## **Fire Station #2**

**Building 68328  
Fort Huachuca, AZ**

**POTR – Phase 1  
Project No 60550**

**DATE: February 26, 2013**

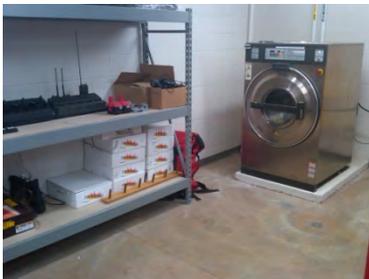
- Would prefer stained concrete floor to the VCT. The VCT pattern in this facility is very “unique”, and takes some getting used to. On the other hand, it appears that the pattern and texture would allow for repairs to be done to the VCT when required without being as apparent as on a solid single-color VCT floor.
